SUBJECT: STAFF OBSERVATIONS OF TESTING FOR GENERIC SAFETY ISSUE 191 DURING FEBRUARY 12 AND FEBRUARY 13 TRIP TO THE ALDEN TEST FACILITY FOR PCI STRAINER TESTS

Observations of Testing at Alden Research Laboratory
February 12 and 13, 2008

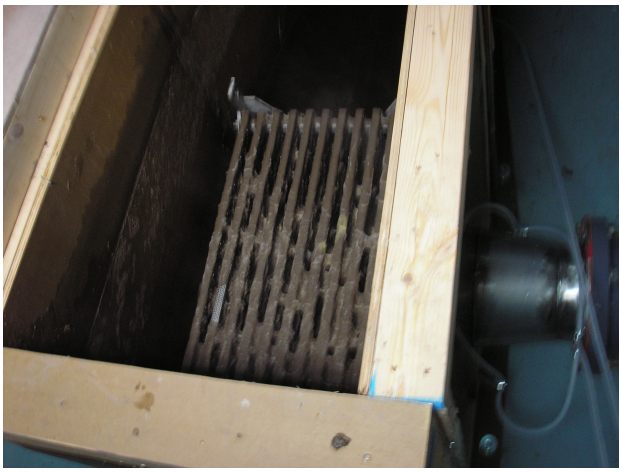
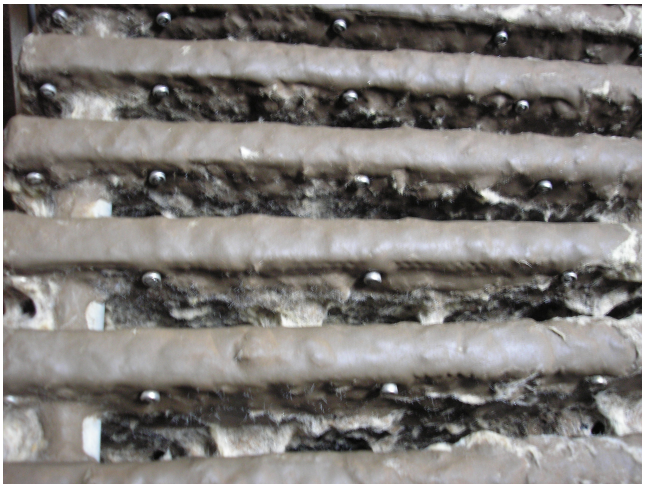
The flume was slowly drained until the pump started sucking air (the strainer submergence at this point was about one inch or less). The pump was secured and the flume was drained completely to allow observation of the debris bed on the strainer. The debris bed appeared to be a chocolate coating over the strainer. It appeared to be a thin bed. In addition, some debris had settled onto the strainer during drain down. It is likely that the entire bed was a homogeneous brown coating before debris fell onto it during drain down. The bed felt like a very dense sponge that was relatively strong under compression, but easily broke apart in tension. Fibers were evident in the brown particulate. (See Photos 5 to 9.)
